Memorandum City of Lawrence Planning & Development Services

RE: MISC NO. 1; VARIANCE FOR CERTIFICATE OF SURVEY; 51 N 2190 RD(MKM)

CSR-13-00517: Consider a variance associated with a Certificate of Survey for approximately 44 acres located at 51 N 2190 Rd. The variance is requested from Section 20-806(d)(2)(i) of the Subdivision Regulations [Section 11-106(d)(2)(i) of the County Code] to allow the creation of Residential Development Parcels which do not comply with the RDP dimensional requirements of the Zoning Regulations. Submitted by Stebbins Surveying LLC, for Louis and Betty Eakes, property owners of record.

Figure 1a. Layout on submitted Certificate of Survey

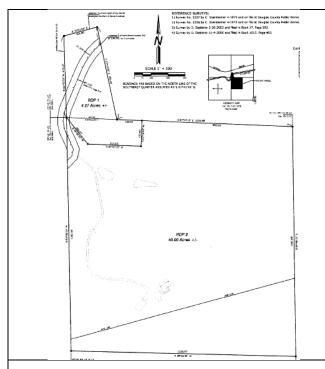
The Certificate of Survey will divide approximately 44 acres in one Certificate of Survey to create 2 Residential Development Parcels (RDP) for residential development as shown in Figure 1a. Approximately 3 acres are being divided from the property which has been developed with a residence to create another parcel that can be developed residentially. Although the property contains over 40 acres, only one certificate of survey with 2 RDPs is possible due to the amount of road frontage that is available. (Figure 1) N 2190 Road is classified as a 'local road' in the Douglas County Access Management Map. Any RDP created in a rural Certificate of Survey on a local road requires a minimum of 250 ft of road frontage. The RDPs both exceed this frontage requirement.

The Zoning Regulations require that each RDP which fronts on and takes access to a local road have a minimum width equal to 90% of the minimum required road frontage, or 225 ft. A variance is being requested from this requirement.

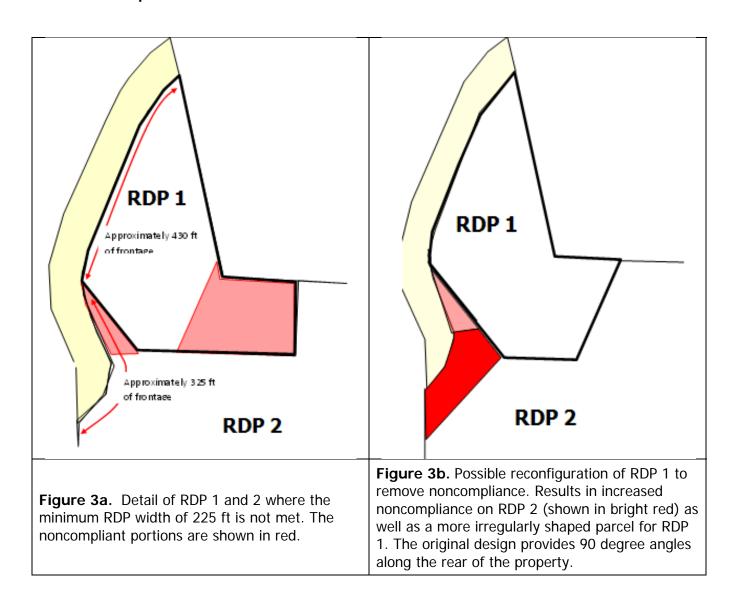
As shown in the detail in Figure 3a, the configuration of the road and the original shape of the parcel prevent the minimum width from being provided in all portions of the Residential Development Parcels (RDPs).

The example in Figure 3b shows a possible reconfiguration of RDP 1 that would provide the required minimum RDP width of 225 ft (approximately) for RDP 1. This reconfiguration would result in an increased portion of RDP 2 that does not comply with the required minimum RDP width of 225 ft (shown in bright red). This reconfiguration also creates a more irregularly shaped boundary for RDP 1, where the originally proposed layout provides right angles at the east boundary of the RDP. The property owner wishes to maintain his access to the 2 ponds that are located on RDP 2 (Figure 1) but he indicated that the lengthening of RDP 1 as shown in the example would interfere with this access. In staff's opinion, as the change to RDP 1 does not remove the noncompliance from the minimum RDP width requirement but shifts the noncompliance to RDP 2 and results in a more irregularly shaped boundary for RDP 1 and possibly impedes access to the existing farm ponds; this reconfiguration is not preferred.

Strict application of these regulations would require the minimum RDP width of 225 ft to be observed. The existing shape of the parcel and the layout of N 2190 Road in this road (required due to the topography of the area) would prevent the division of the 44 acre parcel through the Certificate of Survey process even though the RDPs would exceed the road frontage requirement and the Certificate of Survey would exceed the minimum area requirement as the minimum width requirement could not be met. In staff's opinion this would be an unnecessary hardship upon the subdivider.
